Department of Planning & Housing

SUBJECT: Revised Lot Dimensions for Phase 22 of the Preliminary Plat for Somerset Subdivision

SOMERSET SUBDIVISION
 PRELIMINARY PLAT/MAJOR SITE PLAN

DIMENSION PLAN

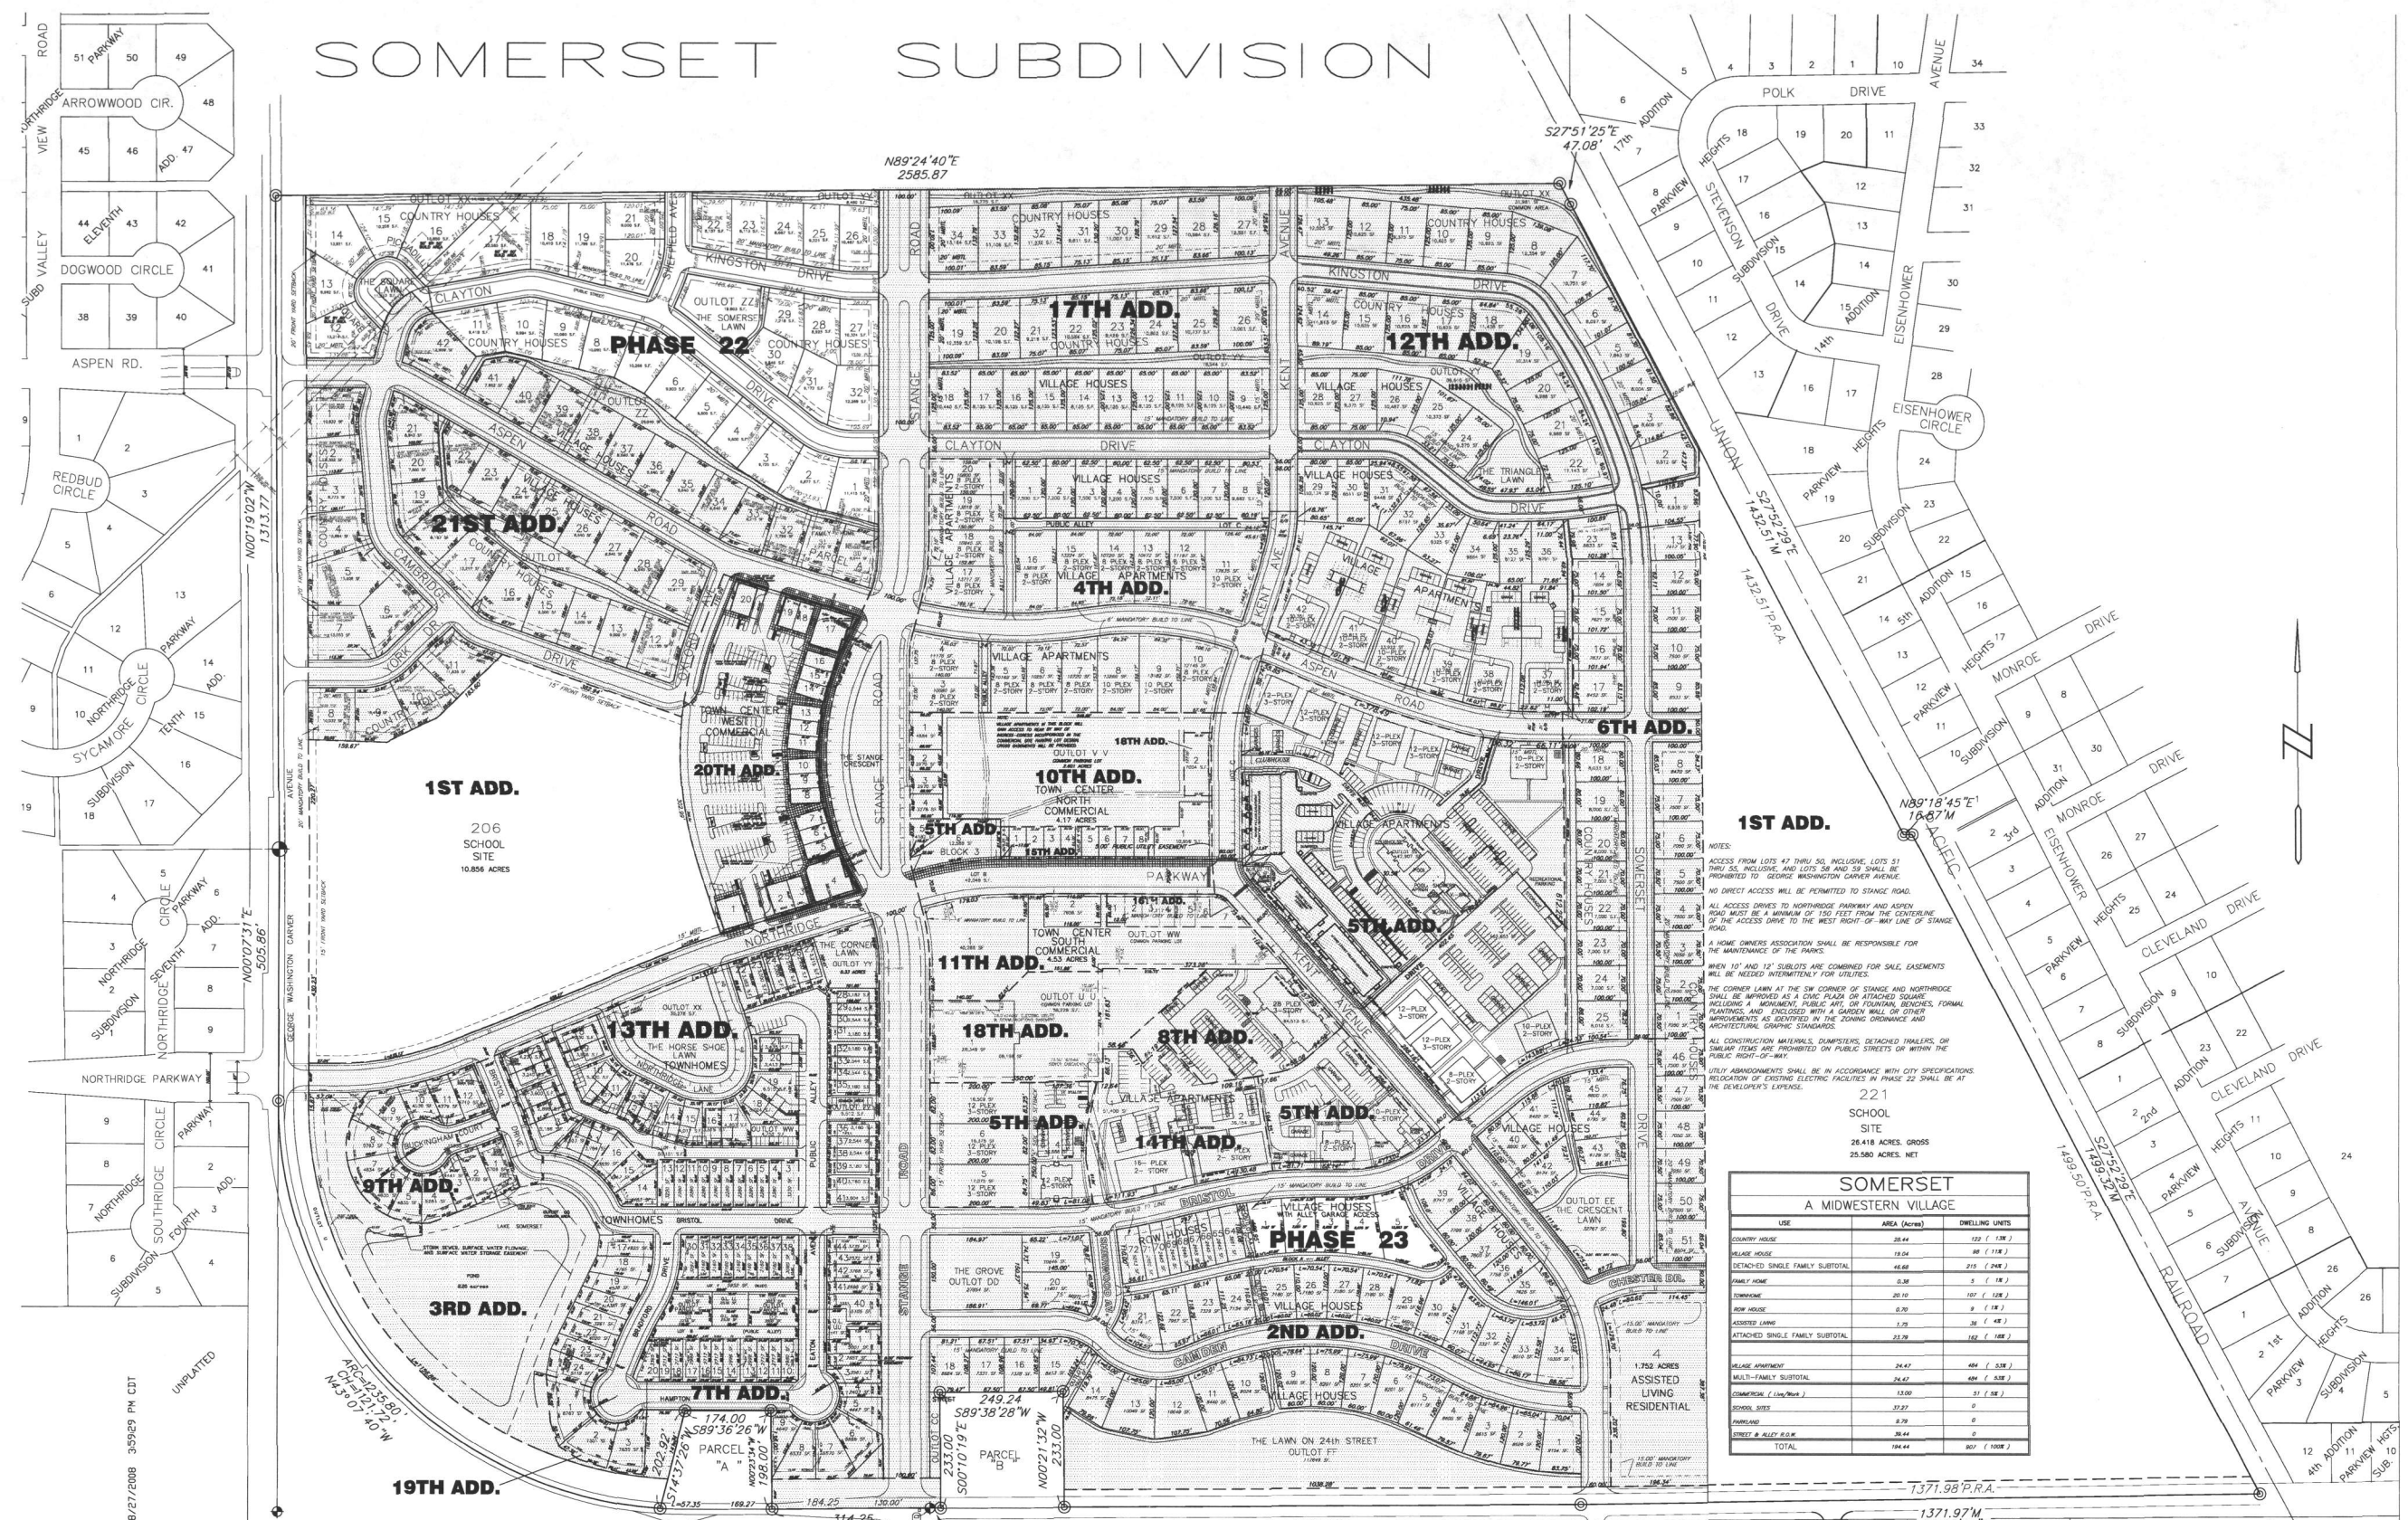
The Planning and Zoning Commission, on October 1, recommended approval of the proposed revisions to the overall dimensions of lots in Phase 22 of Somerset Subdivision, with a condition for approval. The condition specifies that the applicant modify the widths of Lots 23, 24, 25, 28, and 29 to meet the minimum lot width requirement of 72 feet for "Country House" lots, prior to consideration by the City Council. With receipt of the revised Preliminary Plat and changes to lot widths that have been made by the developer, the condition included with the Planning and Zoning Commission recommendation for approval has now been satisfied.

It is therefore recommended that the City Council approve revisions to Phase 22 of the Preliminary Plat for Somerset Subdivision.
